Office Action Summary	Application No. 10/646,008	Applicant(s) MOON, SUNG-JAE	
	Examiner HOAN C. NGUYEN	Art Unit 2871

DETAILED ACTION

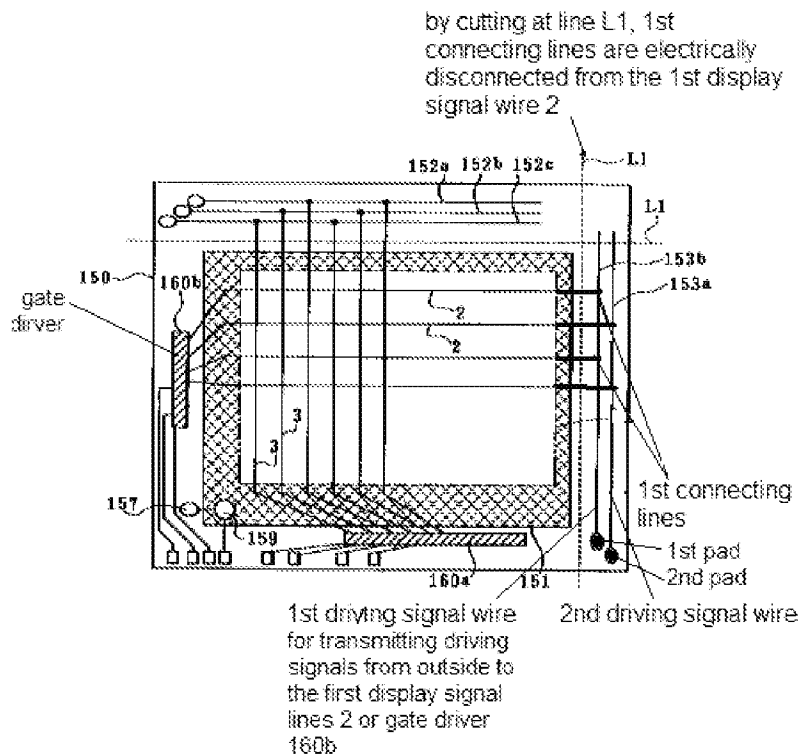
Nagata et al. teach (Fig. 17) a liquid crystal display device comprising:

- a liquid crystal panel including
 - a first display signal wire having a plurality of a first display signal lines 2,
 - a second signal wire having a plurality of a second display signal lines 3 that cross the first display signal lines,
 - a plurality of switching elements (inherence for active matrix display) each of which is connected to both of one of the first display signal lines 2 and one of the second display signal lines 3, and
 - pixel electrodes inherently connected to the switching elements;
- a first driving signal wire 153b transmitting driving signals (an inspection scanning signal) from an outside of the display panel to the first display signal lines 2, wherein the first driving signal wire is separated from the first and

second display signal wires, the switching elements (inherence for active matrix display), and the pixel electrodes, and includes a first pad connected thereto at first end thereof and a second pad connected thereto at a second end thereof shown as above Figure 17 of Nagata et al. (these pads similar to the pads 321p/322p as shown in Fig. 3 of this invention application);

wherein the first connecting lines are electrically disconnected from the part of the first display signal wire after cutting at the cutting line L1.

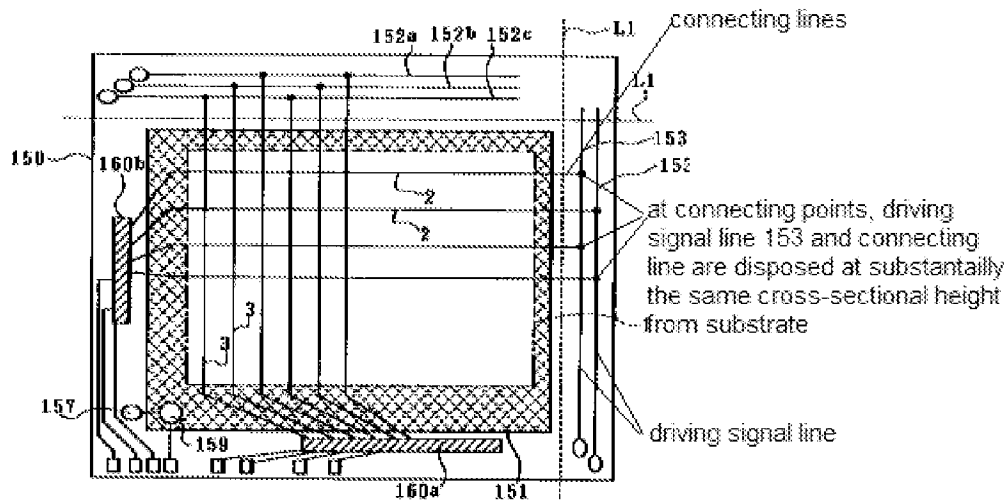
- a substrate;
- a gate driver disposed on the substrate
- a plurality of gate lines 2 electrically connected to the gate driver 160b;
- a plurality of data lines 3 disposed substantially perpendicular to the plurality of gate lines;
- a plurality of switching elements, each switching element being connected to at least one gate line and at least one data line; and
- a plurality of pixel electrodes, each pixel electrode being connected to at least one switching element;
- a driving signal line 153b configured to transmit driving signals from an outside of the display panel to the gate driver 160b through gate lines 2 and also configured to transmit a test signal via a plurality of connecting lines to at least one of the plurality of gate lines,

wherein each connecting line is disposed between, and connected to, the driving signal line and the at least one of the plurality of gate lines, and the driving signal line and the connecting lines are disposed at substantially the same cross-sectional height from the substrate at connecting points as shown in the below figure.

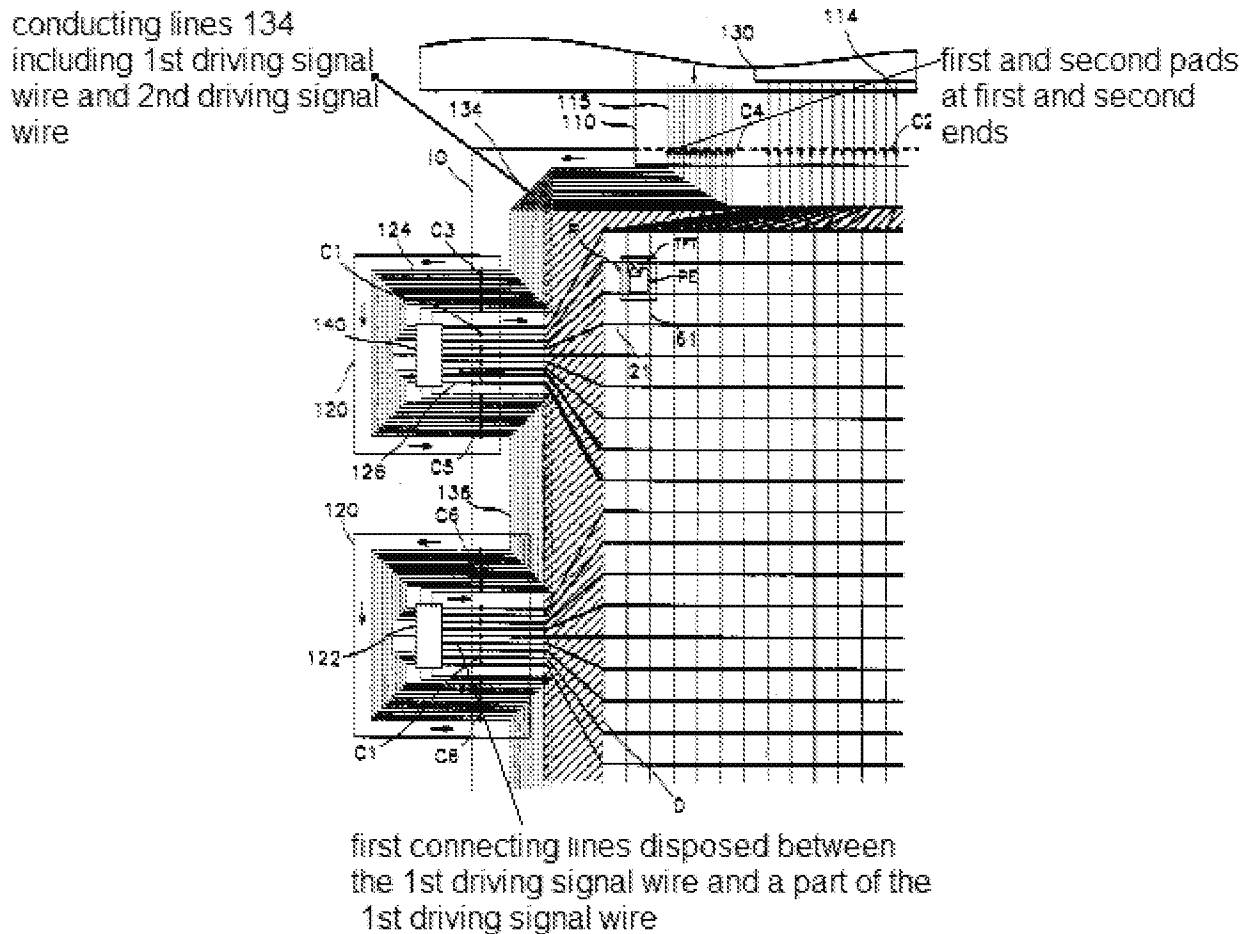
- a liquid crystal panel including
 - a first display signal wire having a plurality of a first display signal lines 21,
 - a second signal wire having a plurality of a second display signal lines 61 that cross the first display signal lines,

- a plurality of switching elements TFT each of which is connected to both of one of the first display signal lines and one of the second display signal lines, and
- pixel electrodes PE inherently connected to the switching elements;

- a first driving signal wire 134 transmitting driving signals from an outside of the display panel to the first display signal lines 21, wherein the first driving signal wire is separated from the first and second display signal wires, the switching

elements, and the pixel electrodes, and includes a first pad C4 connected thereto at a first end and second pad C4 thereto at a second end thereof;

- a plurality of first connecting lines (between the chip 120/122 and the contact C1) at disposed between the first driving signal wire and a part of the first display signal wire 21, and connected to at least one of the first driving signal wire and the part of the first display signal wire.

wherein the first connecting lines are electrically disconnected from the part of the first display signal wire before contact at C1

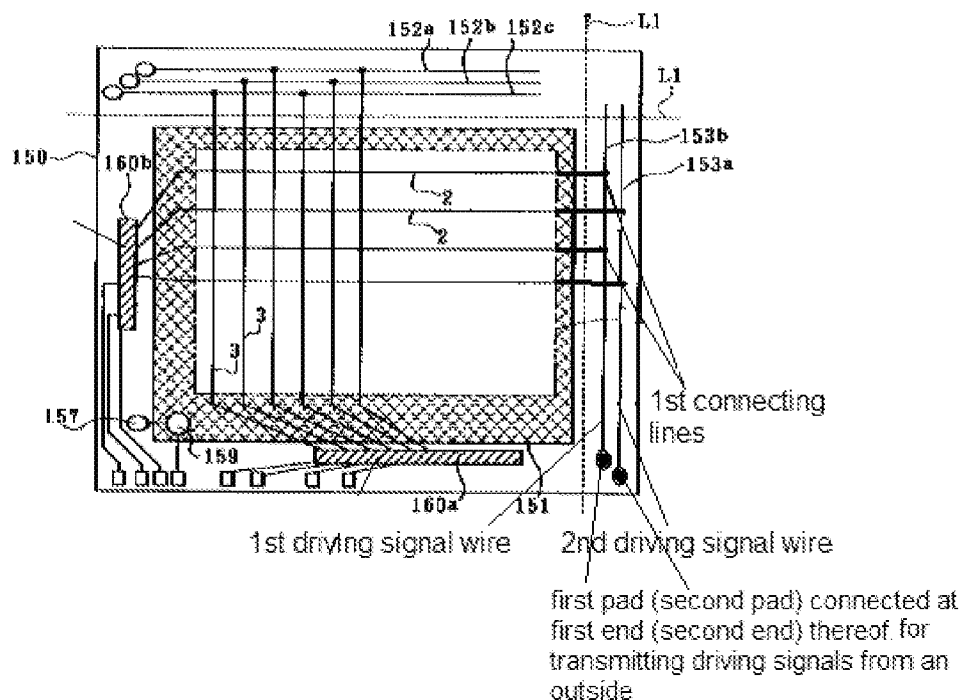
3. Nagata does not disclose: wherein each connecting line is disposed between, and connected to, the driving signal line and the at least one of the plurality of gate lines, and the driving signal line and the connecting lines are disposed at substantially the same cross-sectional height from the substrate as claimed in independent claim 32 of the present invention.

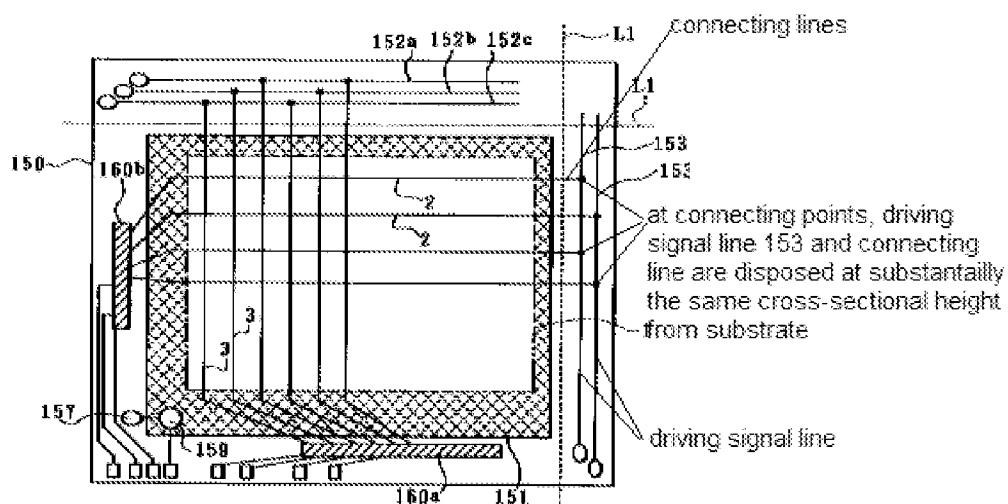
2. Nagata discloses a first driving signal line configured to transmit driving signals from an outside of the display panel to the gate driver 160b through first display signal lines/gate lines 2 and also configured to transmit a first test signal via a plurality of first connecting lines to at least one of the plurality of gate lines as claimed in independent claim 27 of the present invention.

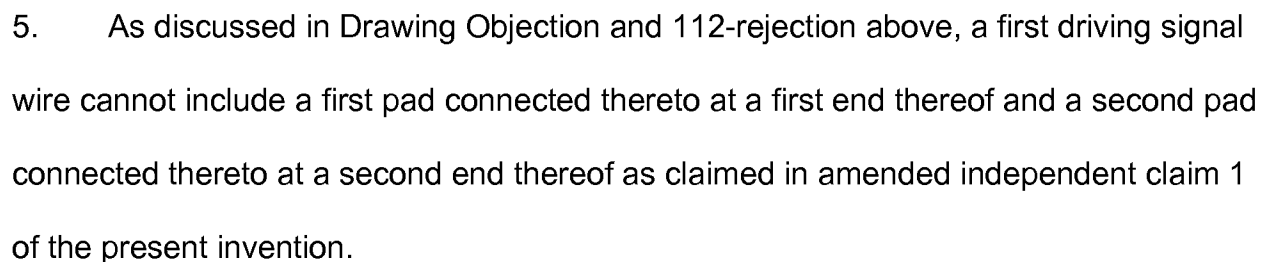
3. Nagata discloses: wherein each connecting line is disposed between, and connected to, the driving signal line and the at least one of the plurality of gate lines, the connecting lines are disposed at substantially the same cross-sectional height from the substrate at connecting points as shown in the below figure:
